# Product Change Notification

Product Change Notification: P-20-018560

DMC-M 99

Module

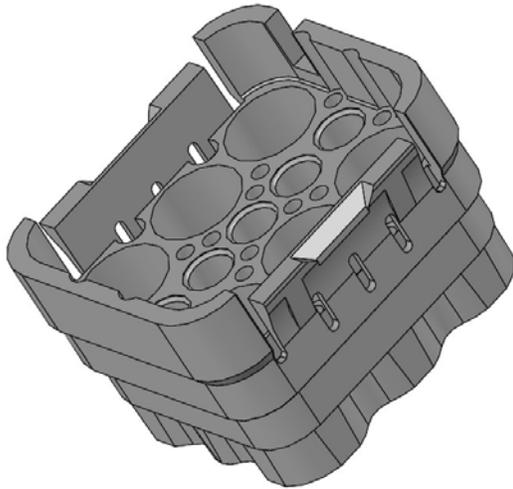
Material change for module. Before: ULTEM 5211, polyetherimide reinforced with 20% glass fiber After: ULTEM 5111, polyetherimide reinforced with 10% glass fiber Test are compiled in report PVE 732-186 VA

Product improvement. This material improves mechanical resistance, and module assembly due to a better flexibility of the lateral clips Uniformization of the material with other module.
